# 2016 Annual Inspection Report

for Compliance with the Coal  
Combustion Residuals Rule  
(40 CFR Part 257)

## **Valmont Station**

**January 18, 2017**

## Appendix A – Landfill Site Map

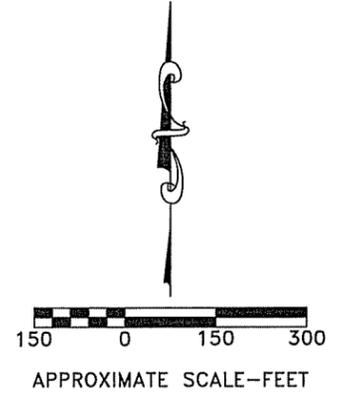
Notes in red added by HDR Engineering for CCR Annual Inspection Report, January 2017
